Nebraska Public Power District

NLS2004128
October 12, 2004

Subject: Regulatory Conference - Request for Additional Information
Cooper Nuclear Station, Docket 50-298, DPR-46

Reference: Nuclear Regulatory Commission (NRC) Inspection Report
05000298/2004014, dated August 12, 2004

615W101A SCAN
Figure 1

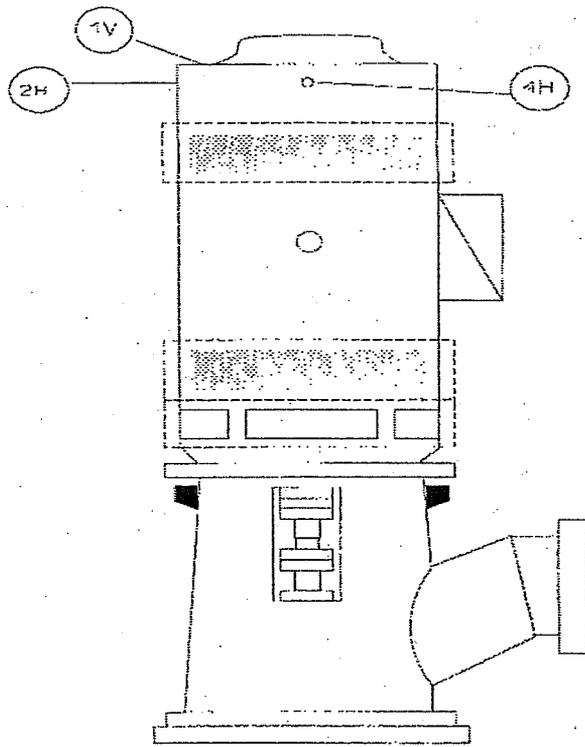
The most recent B and D Service Water (SW) Pump Vibration Data, including alert and action levels, prior to the condition that existed when the SW valves were mispositioned.

The most recent vibration data for the B and D SW pumps prior to the condition was from the 1/5/04 performance of 6.2SW.101, "Service Water Surveillance Operation". The following is the data obtained:

Recorded Value	Alert Level	Action Level
B SW Pump			
Location 1V	0.079	0.325	0.700
2H	0.116	0.325	0.700
4H	0.100	0.312	0.700
D SW Pump			
Location 1V	0.115	0.270	0.648
2H	0.105	0.275	0.660
4H	0.049	0.170	0.408

Locations can be seen in Figure 1 on Page 2 of this Attachment.

Figure 1

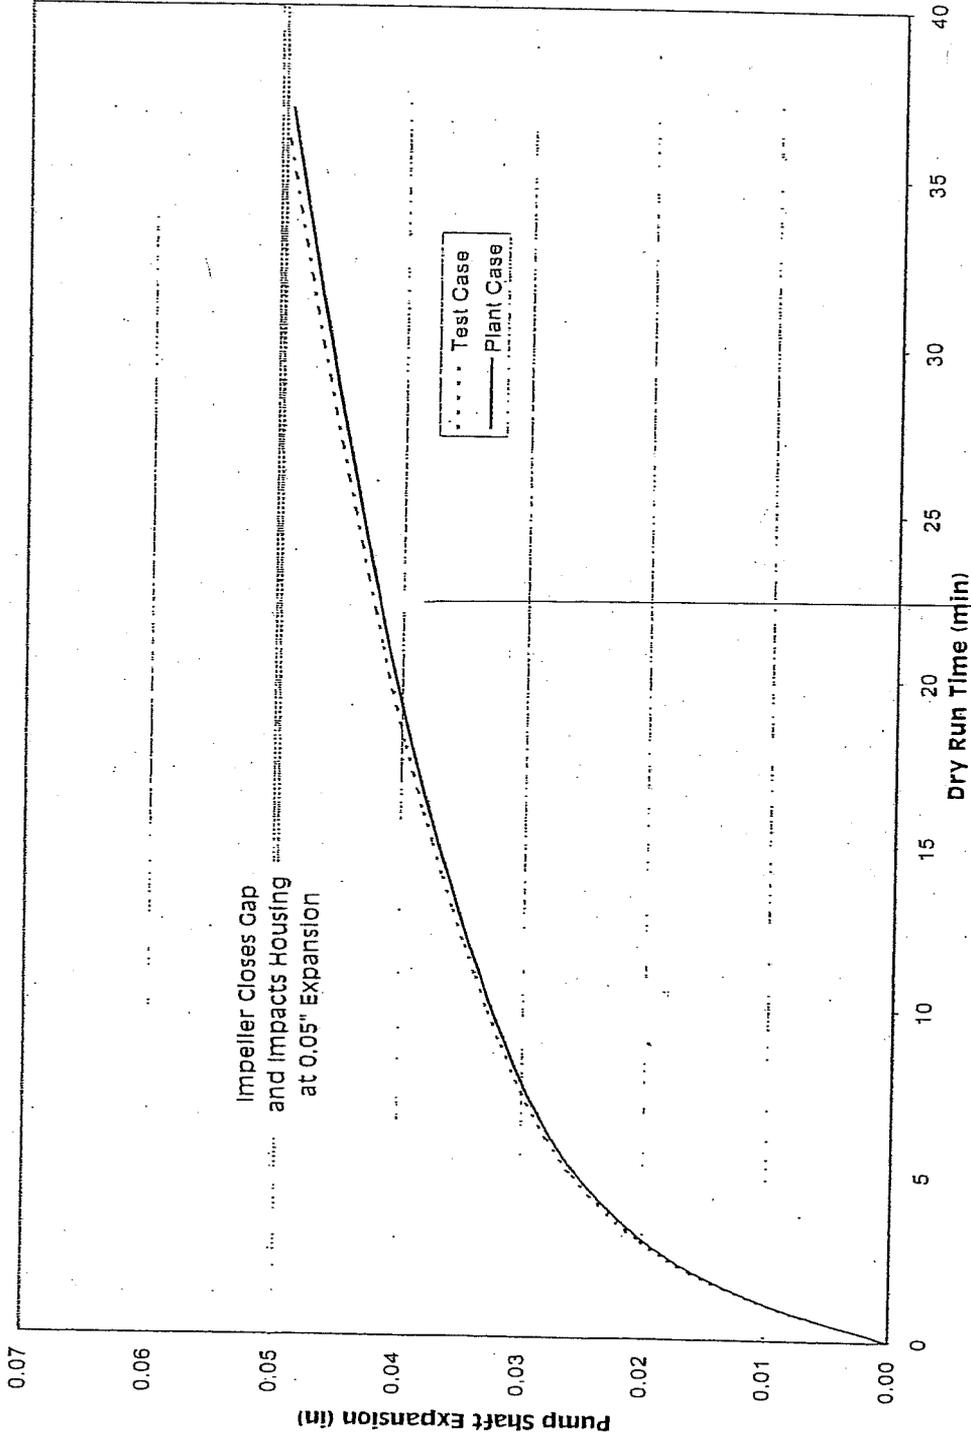
What is the difference in shaft expansion for the test conditions compared to the cooler water that existed during the 21 day period?

Test Case: Using the initial estimated heat generation rate at the shaft/bearing interface, the shaft was found to heat up and thermally expand 0.05" in approximately 15 minutes of dry operation. Therefore the impeller would contact the bowl in 15 minutes, whereas during the test, contact occurred after approximately 37 minutes. To calibrate the model with the test results, the heat generation rate was reduced to cause the shaft to expand 0.05" in approximately 37 minutes. The pump shaft expansion as a function of time is shown in Figure 1. Using the calibrated heat generation rate, the shaft axial expansion after 37 minutes was 0.050".

Plant Case: The model was re-analyzed for the extreme plant operating conditions (bay temperature of 43°F and water temperature of 38°F due to loss of de-icing flow into the river water). The starting temperature of the pump components and the water temperature were changed to the plant conditions. The calibrated bearing heat generation rate was used in the analysis. The results of the analysis are shown in Figure 1. The results in Figure 1 show that the shaft expansion for the test case and the plant case are very similar - the two curves lay almost on top of each other. The pump shaft thermal expansion after 37 minutes was 0.049", about 2% less than the expansion calculated for the test case.

The results in Figure 1 show the shaft thermal expansion up to the point where the impeller makes contact with the pump bowl. After that point, the expansion will follow a steeper curve as a function of time. This occurs because impeller contact causes compressive and lateral loading of the shaft, which results in increased shaft orbiting, much larger bearing loads, and greater heat generation. The increased bearing loads and heat generation caused the severe bearing damage observed on the test pump. Also during this period, impeller and bowl material are being removed. Finally an equilibrium point is reached after about 3.5 minutes, when bearing heat generation has peaked and no additional shaft expansion occurs. After approximately 7.5 minutes, stable pump operation resumes. This series of events, including the total shaft expansion and amount of material removed by the impeller scraping the bowl, will be essentially the same for the test case and for the plant case.

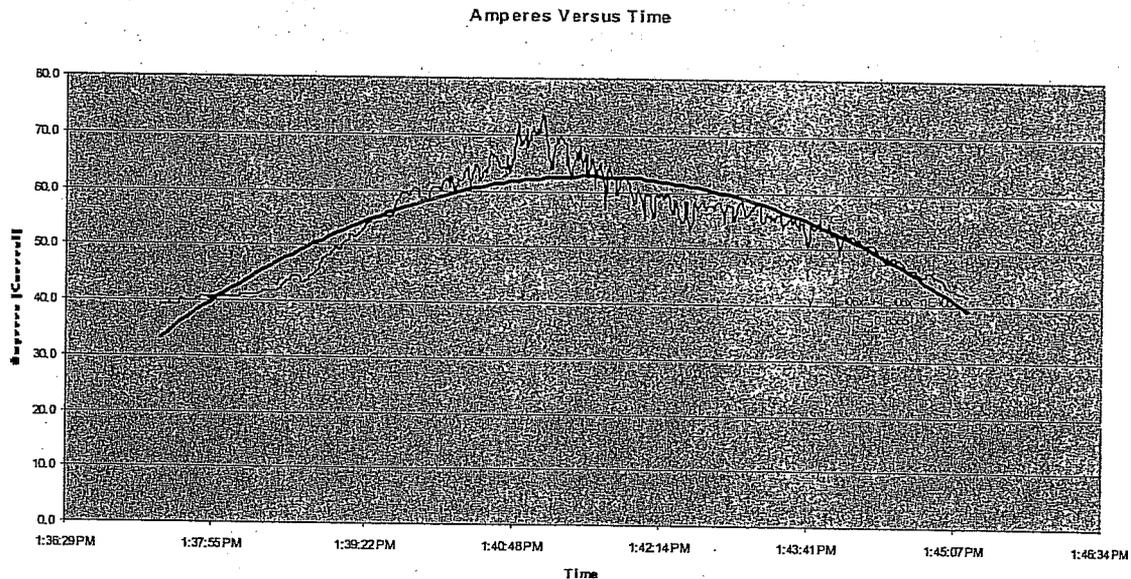
How much more force would it take to cause a pump/motor breaker trip (overcurrent)?

In order for the pump motor to trip on overcurrent, the force would have to nearly double (increase approximately 85%). However, as supported by the response to the question on shaft elongation, there is no mechanism present that would cause the heat-up rate of the shaft to increase.

During the impeller/bowl grinding period, which was about 7 minutes, slightly less than 38 mils of material was removed. This is a removal rate of approximately 5.4 mils per minute. The reason for the increased expansion rate during the impeller/bowl grinding period is due to the shaft being under compression. This results in the shaft orbiting, creating higher lateral bearing loads, which in turn causes more friction between the bearings and shaft, causing the shaft to heat up at a faster rate. However, once the temperature of the bearing approaches 300 degrees F, the rubber breaks down and portions peel away, thus limiting the mechanism (i.e., resistance between the shaft and bearing) for further increase in temperature. Once again, during this 7 minute period of time where grinding occurred, the heat up and cooldown process follows an exponential curve based on Newton's Law of Cooling. This is noted in the following graph, which has a parabolic curve fitted to the ampere data.

Thus, the power needed by the motor to sustain the machining rate between the impeller and bowl would not have been much more than that already recorded in the test. Note that the parabolic curve fit in the graph has a fit "R" value of 93%, which is a good correspondence.
